**PLANNED UNIT DEVELOPMENT  
STAFF REPORT****Date: September 17, 2008****DEVELOPMENT NAME**

KLK, LLC

**LOCATION**3704 Dauphin Street  
(Northwest corner of Dauphin Street Service Road and Du  
Rhu Drive).**CITY COUNCIL  
DISTRICT**

**CONTEMPLATED USE**Planned Unit Development Approval to allow shared  
access between two building sites.**TIME SCHEDULE  
FOR DEVELOPMENT**

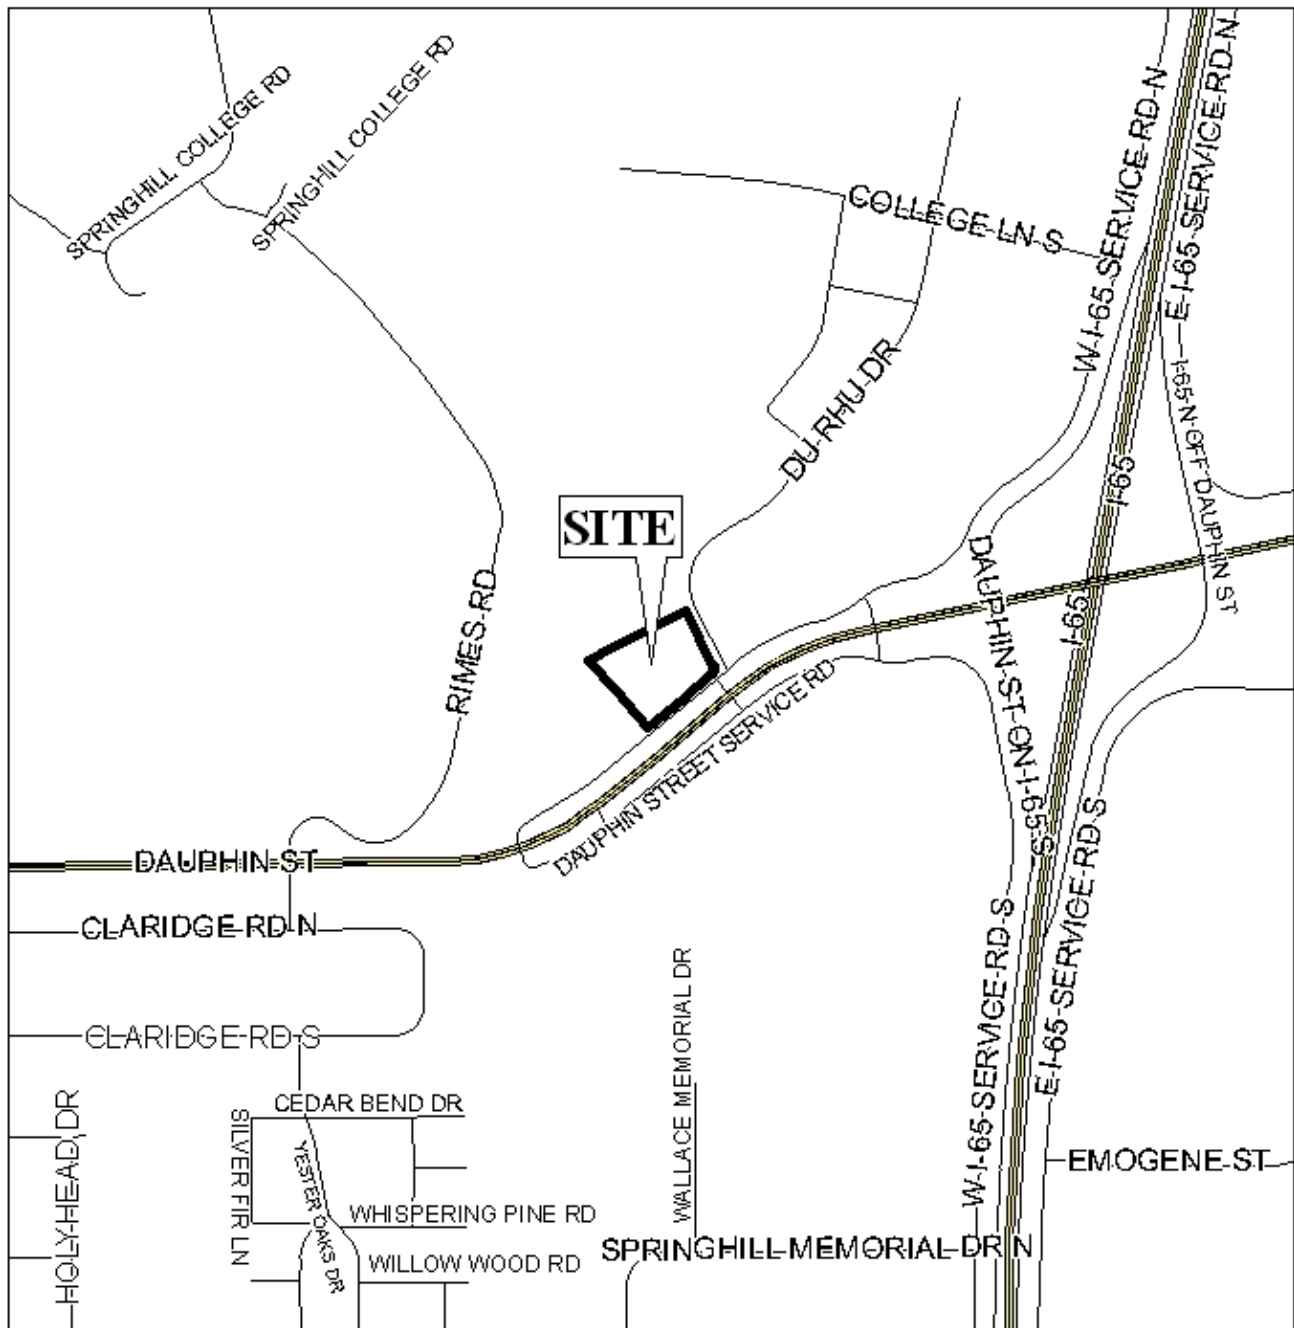
Driveway number, size, location, and design to be approved by Traffic Engineering and conform to AASHTO standards. No details are given for the location of the ATM machine and a line of sight problem could be created. To avoid conflicting movements, a yield sign should be installed for the one-way drive behind the Jewelers where it meets the turning traffic from the bank. All one way areas should be signed and marked to MUTCD standards.

Currently, the site consists of a building with two parking lots, one in the front directly off of the Dauphin Street Service Road and another in the back. The two parking lots are connected by a 24-foot, two-way drive aisle with no connection to the adjacent site to the northeast which is also included in this application. It should also be noted that the site's existing dumpster structure is located in the rear parking lot.

The applicant proposes to convert the existing 24-foot, two-way drive aisle into two, 10-foot, one-way drive-up teller queuing lanes and construct a 12-foot wide one-way drive aisle on the adjacent building site to the northeast for traffic to flow out of the site and onto DuRhu Drive. This project will result in several circulation and emergency vehicle access issues.

Firstly, the existing parking lot in the rear of the site would only be able to be accessed through the drive-thru teller queuing lanes, thus, if there were people in line to be assisted in the queuing spaces, the person wishing to park in the rear would essentially have to wait in line to drive through the teller area and then to the parking lot. This would result in traffic unnecessarily backing up in the queuing spaces.

Additionally, the queuing lanes, at 10-feet wide, would not be sufficiently wide enough to allow emergency vehicles to access the rear of the building or the rear parking lot. The queuing lane width would also not be sufficient for a waste collection truck to access the site's dumpster.

Finally, it should be noted that this project, as proposed, would result in the site falling below the minimum parking requirements of the Zoning Ordinance. The existing building is 12,980 square feet in area. For this size building and use, 43 parking spaces are required. Due to the ATM addition, the applicant's proposed removal of eight existing parking spaces, leaving only 42 spaces, will result in an insufficient number of parking spaces under the zoning ordinance.

- 1) The proposed alterations would adversely affect traffic circulation;
- 2) The proposed alterations would adversely affect emergency vehicle access to the rear of the property;
- 3) The proposed alterations would adversely affect trash collection; and
- 4) The proposed alterations would result in the site falling below the minimum parking requirements of Section 64-4.A.6 of the Zoning Ordinance.
